Pentium® Processor Specification Update

Release Date: January 1999

Order Number 242480-041

The Pentium® processor may contain design defects or errors known as errata which may cause the product to deviate from published specifications. Current characterized errata are documented in this Specification Update.

Figure14-1. Maximum Undershoot Level, Undershoot Threshold Level, and Undershoot Threshold Duration

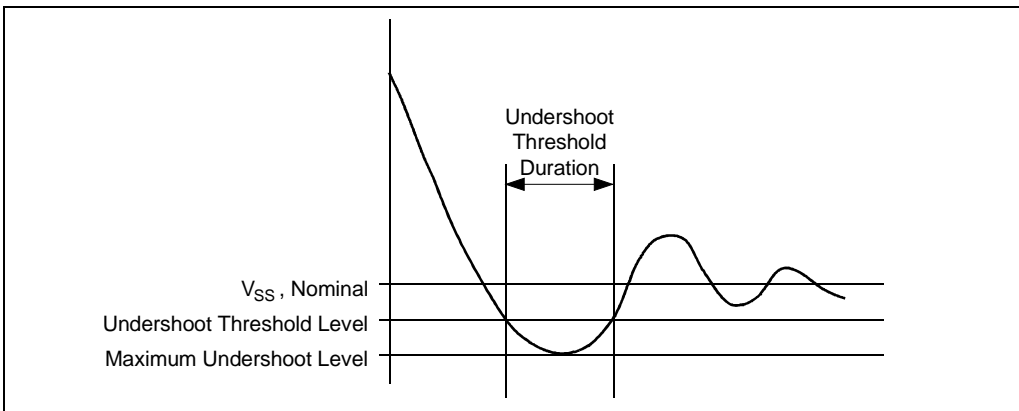
MAXIMUM RINGBACK SPECIFICATION: The maximum ringback of CLK associated with its low state (undershoot) must not exceed 0.8V as shown in Figure 14-1.

MAXIMUM UNDERSHOOT AND MAXIMUM RINGBACK SPECIFICATIONS: The display should show continuous sampling (e.g., infinite persistence) of the waveform at 500 mV/div and 5 ns/div (for CLK) for a recommended duration of approximately five seconds. Adjust the vertical position to measure the maximum undershoot and associated ringback. There is no allowance for crossing the maximum undershoot or maximum ringback specifications.

UNDERSHOOT THRESHOLD DURATION SPECIFICATION: A snapshot of the clock signal should be taken at 500 mV/div and 500 pS/div (for CLK). Adjust the vertical position and horizontal offset position to view the threshold duration. The undershoot threshold duration is defined as the sum of all time during which the clock signal is below -0.5V within a single clock period. The undershoot threshold duration must not exceed 20% of the period.

This undershoot specifications are illustrated graphically in Figure 14-1 and Figure 14-2.
